PROTOTYPE CARBON FUND

DETERMINATION OF THE ROMANIA AFFORESTATION OF DEGRADED AGRICULTURAL LAND PROJECT

FINAL REPORT No. 2002 - 1

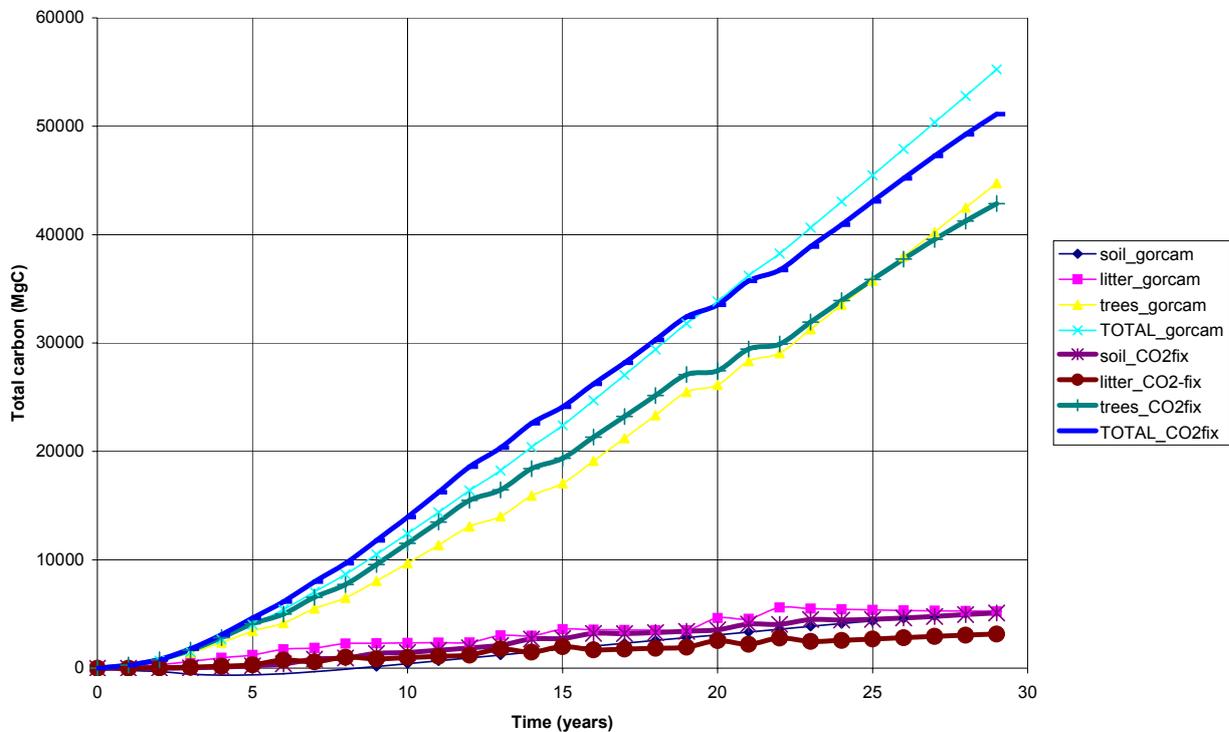
Relative differences between the GORCAM and the CO2fix model runs are insignificant (except for Robinia V), if one uses the same model inputs. The diagram below shows this using the Robinia IV example. Some of the difference can be explained with the way the models handle thinning (GORCAM assumes a somewhat increased growth rate after thinning), some of the difference results from the fact that the latest GORCAM version allocates biomass to product and slash categories uniformly across thinning events, whereas CO2fix allows changes between thinning events. Another difference is that GORCAM assumes the fraction of root biomass to be constant over time, whereas CO2fix does not. All in all, however, the differences are much smaller than the uncertainties underlying the input parameters of both models. Especially the soil carbon balance is highly sensitive to the combination of initial carbon stock and decay rate. Further, the yield table values are 30+ years old and management regime, as well as ambient conditions, may have changed significantly since then. Therefore, it is of greater importance to investigate the difference between measurement-based and model-based carbon estimates (there is currently a difference by a factor of 1,5 to 4), rather than further refining the model calculations.

Robinia site class V:

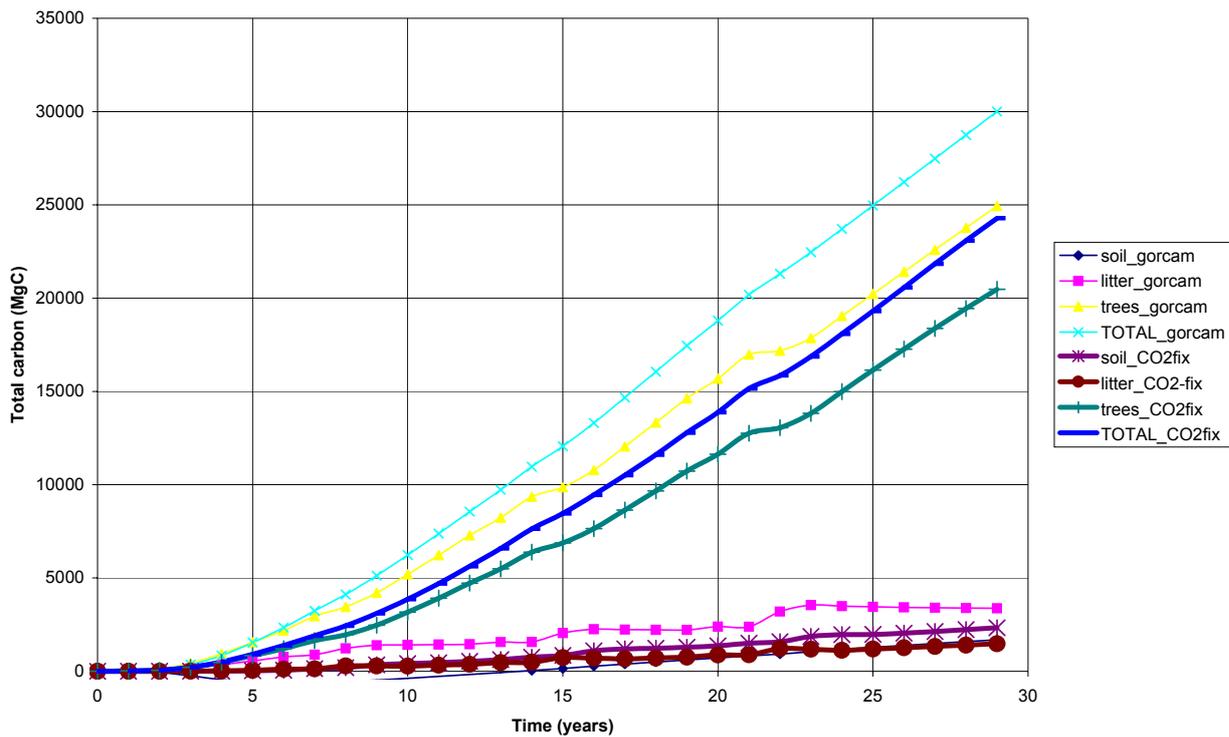
The match for Robinia V is not as good as for Robinia III and IV, the main difference being carbon in biomass.

The value marked yellow is questioned here. Looking simply at predicted yield and area, one would expect that this yield class sequesters 59% of what yield class IV sequesters. This would result in a sequestration of 25 270 tC in biomass. However, the calculated amount from CO2fix is only 20477 tC.

Poplar site class III:

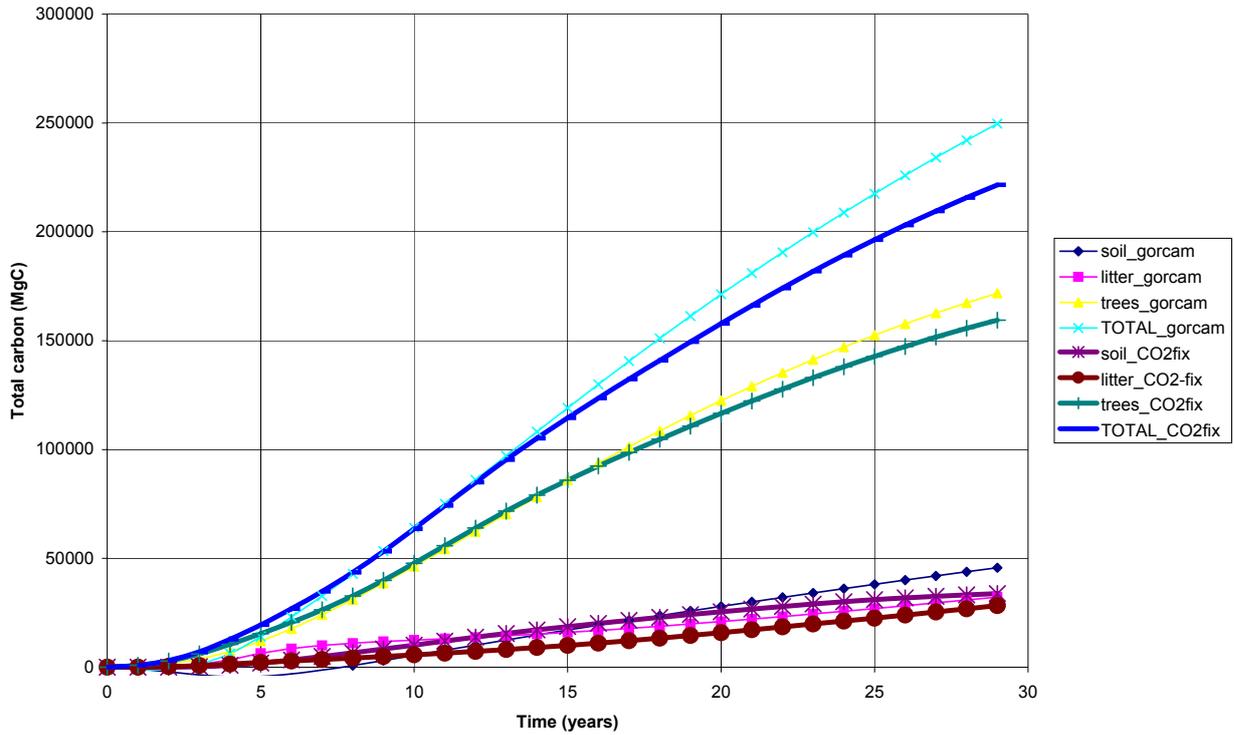
Main difference is that CO2fix has soil carbon increase from the beginning, whereas GORCAM shows an initial decrease. On the other hand, GORCAM shows a somewhat greater increase in the later years. Anyway, good match!

Oak site class IV:

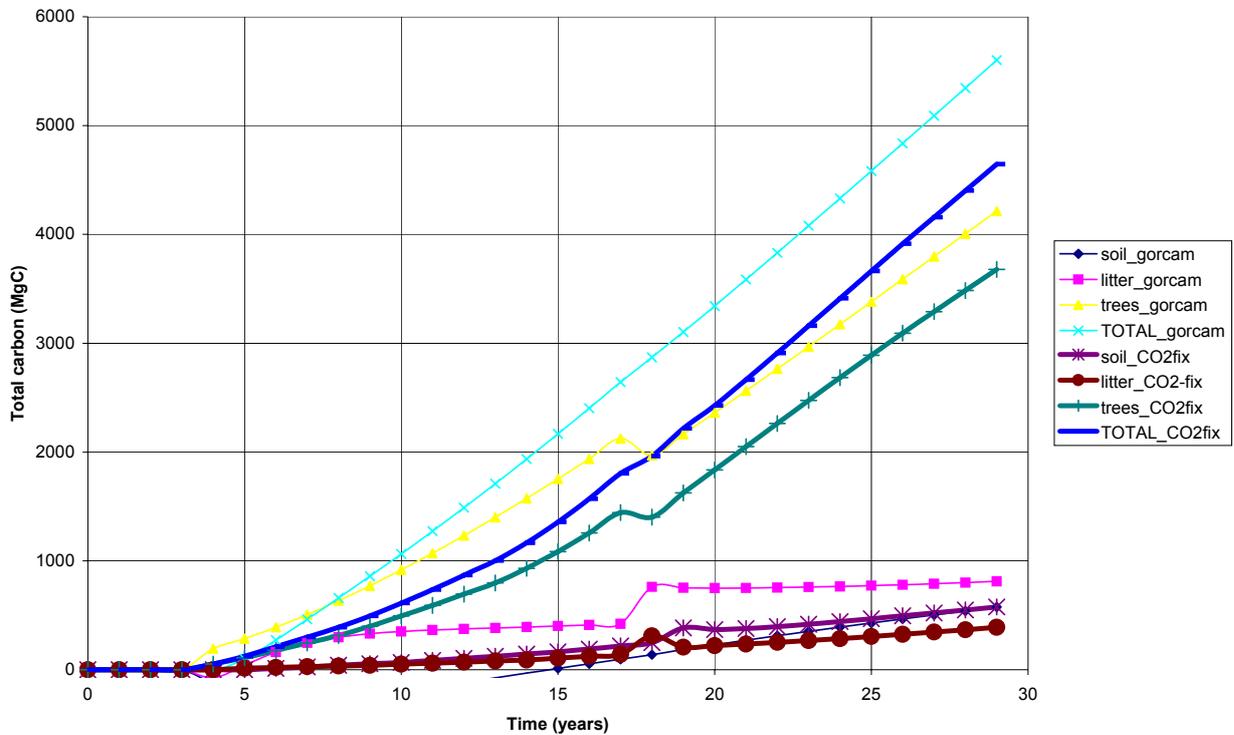
Here the biomass values from CO2fix seem to be too low based on the yield table. This can also be demonstrated using a simple example. The yield table at age 10 shows a volume of 30 m3. This can be converted with the density used of 0.645 (see tech report page 9), carbon density of 0.5, and a low estimate of root biomass of 15%, and neglecting foliage, to 12 tC/ha, or for 142 ha, 1580 tC. GORCAM below already has a somewhat lower value than that, but CO2fix gives a much lower value at around 800 (the file “carbon spreadsheet” contains a biomass carbon value of 798 at time 13 (age 10 of this stand which is only planted in year 4)).

This difference in tree biomass may also explain why GORCAM has higher values for litter than CO2fix.

Oak site class V:

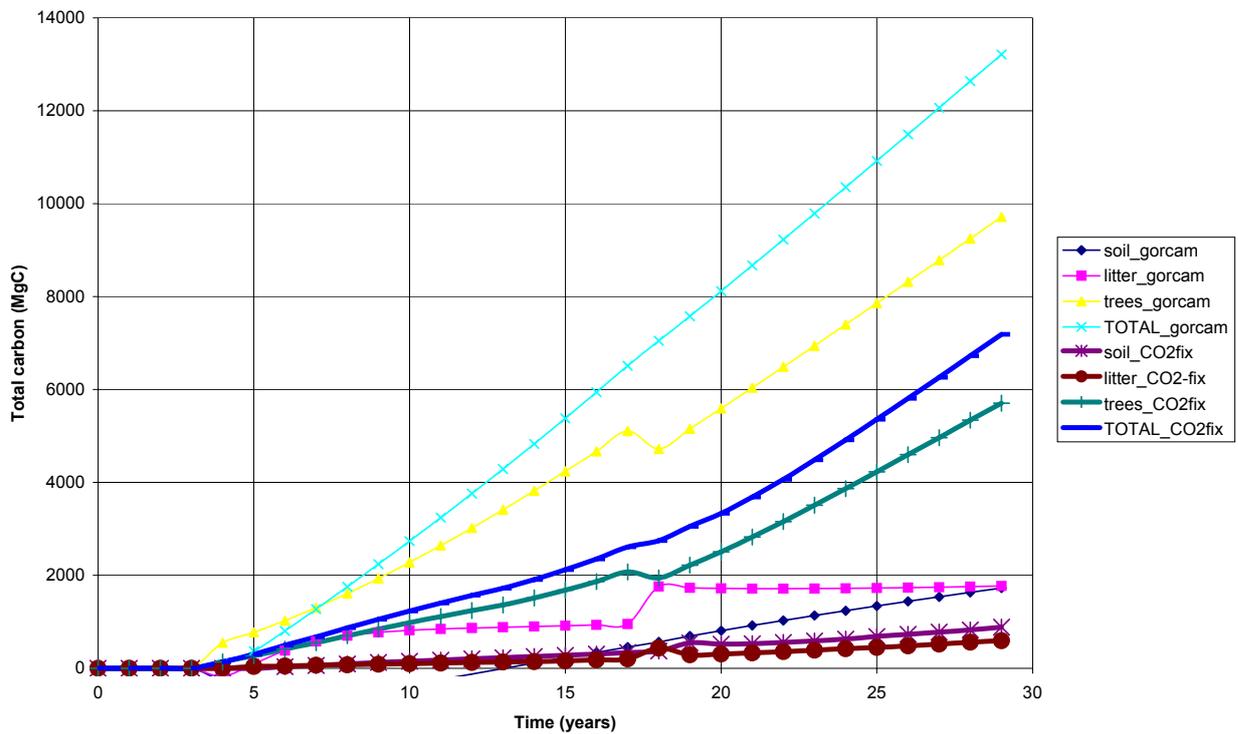
Here again the biomass values from CO2fix seem to be too low based on the yield table.

The yield table at age 10 shows a volume of 18 m³. This can be converted with the density used of 0.645 (see tech report page 9), carbon density of 0.5, and a low estimate of root biomass of 15%, and neglecting foliage, to 6,7 tC/ha, or for 430 ha, 2870 tC. CO2fix result at time 13 (age 10): 1363 tC. Something must be wrong here.
